# Clonburris T3

## Compliance Report

CLB-T3-ZZZ-SW-DTM-RP-DBFL-CE-0006

Project Title:	<b>Clonburris T3</b>		
Document Title:	<b>Compliance Report</b>		
File Ref:	<b>CLB-T3-ZZZ-SW-DTM-RP-DBFL-CE-0006</b>		
Status:	<b>P3 - Planning</b>	Rev:	<b>0</b>
	<b>S - Issued</b>

Figure 1 – Type 1 Tree Pit Surface Water Flow

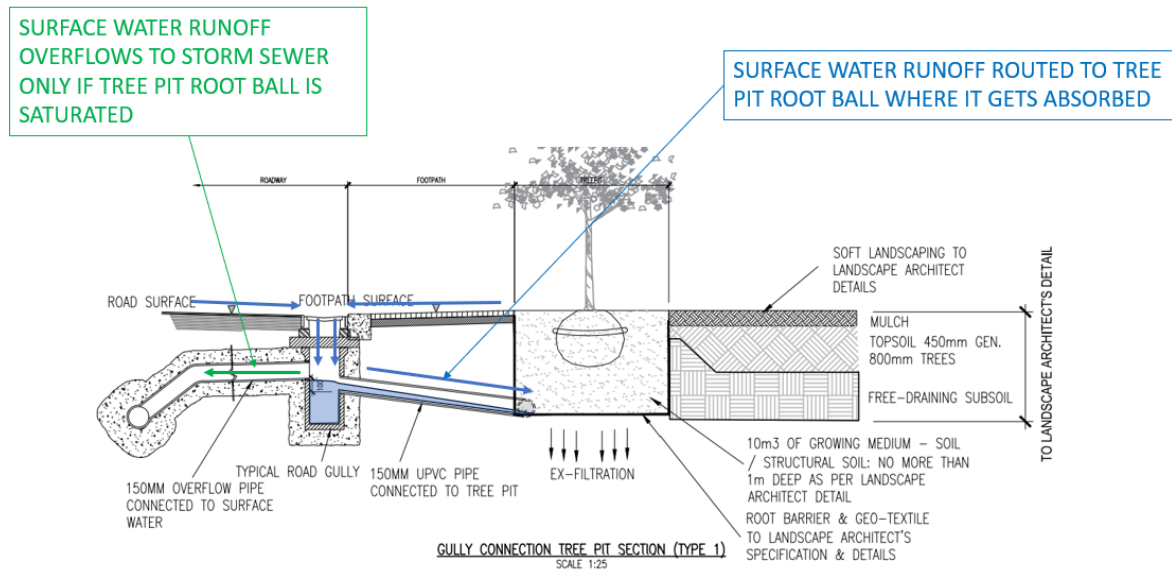
Water Services are not satisfied that Condition 11 of SDZ22A/0017 is compliant. The proposed development shows road gullies in front of tree pits which stops surface water reaching the tree pits. This contradicts SuDS requirements for the site. In order to address SuDS requirement for the site, submit a revised drawing in plan and cross-section view showing surface water layout such that surface water can enter tree pits and not have road gullies stopping surface water entering the tree pits. Examples of SuDS can be found on SDCC website at <https://www.sdcc.ie/en/services/environment/environmental-health/water-services/sustainable-drainage-systems/>

The general drainage layout and gully locations for the proposed development have been revised as per the enclosed drawing CLB-T3-94-SW-DTM-DR-DBFL-CE-1311. Several gullies have now been removed in order to maximise the surface water runoff from the roads which is to be diverted to tree pits and other SuDS features. Refer to drawing CLB-T3-95-SW-DTM-DR-DBFL-CE-1211 which shows the locations of kerb inlets along the road edges, allowing surface water to enter SuDS features such as tree pits.

The tree pit details have also been revised to better align with the recently issued "Sustainable Drainage Explanatory Design & Evaluation Guide 2022". See enclosed drawing CLB-T3-94-SW-XXX-DR-DBFL-CE-5304 for the revised tree pit details. Note the significant amount of "Type 2" tree pits on the enclosed drainage layout, which allows surface water runoff from the roads to discharge directly to tree pit/bioretenion surface and infiltrate.

It is also noted that in Type 1 tree pits gullies do intercept water initially however they direct discharge to tree pit structure for infiltration and plant uptake with only a high level overflow to the surface water network as shown in Figure 1 below. Refer to details provided on drawing CLB-T3-94-SW-XXX-DR-DBFL-CE-5304 for all SuDS tree pit details.

*Figure 2 - Extract from the Surface Water Management Plan Dr 190113-DBFL-SW-ST-DR-C-1101 (Catchment Plan)*

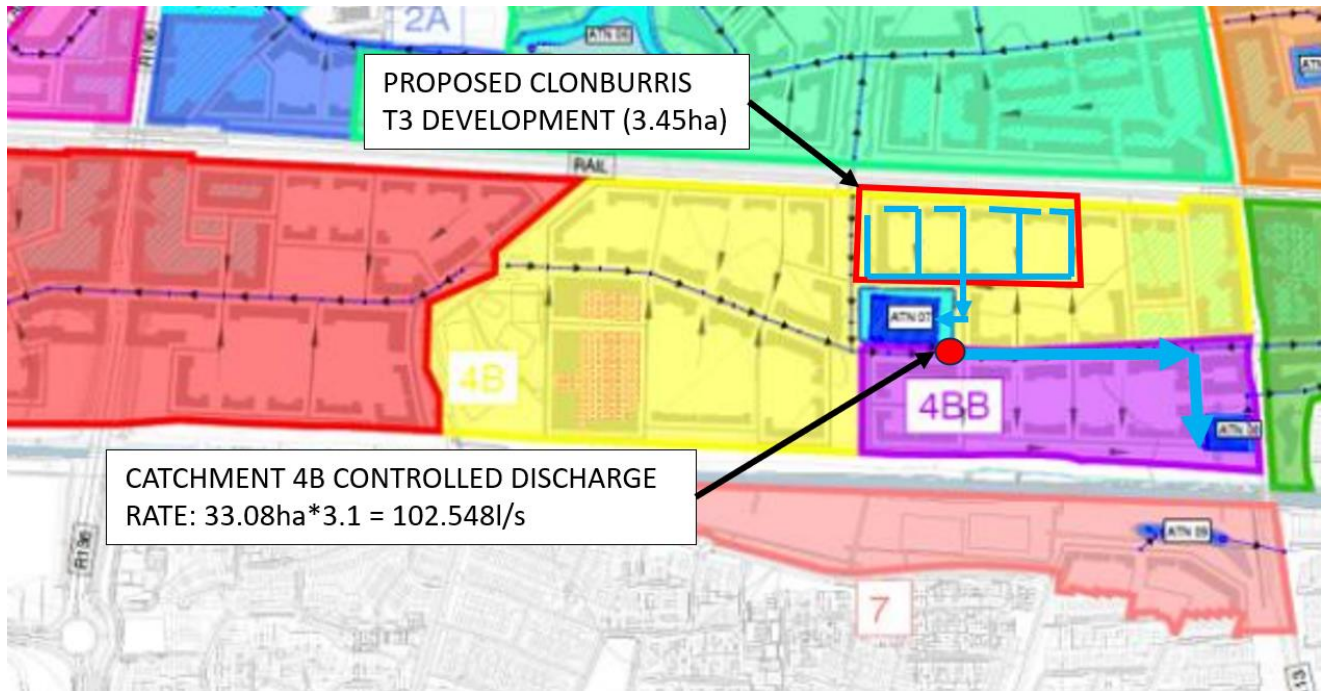
It is unclear how 450.2 l/s discharge rate relates to pre designed rates for Clonburris in Surface Water Management Plan 2020. Submit a report and drawing that shows the discharge rate from proposed in litres per second per hectare and in litres per second. The discharge rate shall be in line with pre-designed surface water discharge rates for Clonburris as per Surface Water Management Plan 2020.

The 450.2l/s discharge rate referred to in the previous Compliance submission is the peak discharge rate from the proposed development. However, The surface water runoff is attenuated and the flow is controlled to 3.1l/s/ha further downstream before leaving the surface water catchment as required by the Surface Water Management Plan.

As detailed in the information submitted for Planning and the request for Further Information, there is no detention basin as part of the proposals in this application as the subject development falls within surface water sub-catchment 4B of the Clonburris SDZ. This catchment is attenuated regionally (ATN07) as required by the Surface Water Management Plan. The regional attenuation

basin ATN07 is currently being constructed as part of the adjacent Clonburriss Joint Infrastructure Works (planning ref SDZ20A/0021) where the surface water discharge will be controlled to 3.1l/s/ha as shown in Figure 2.

As previously detailed in the Infrastructure Design Report, Section 3.4.1 issued for Planning, the attenuation volumes required for the proposed Clonburriss T3 are fully allowed for within the Regional Attenuation Basin ATN07 where the flow from the catchment is controlled to 3.1l/s/ha. Refer to section 3.4.1 of the Infrastructure Design Report issued for Planning for further information on how attenuation for the proposed Clonburriss T3 development is allowed for within the regional attenuation basins.
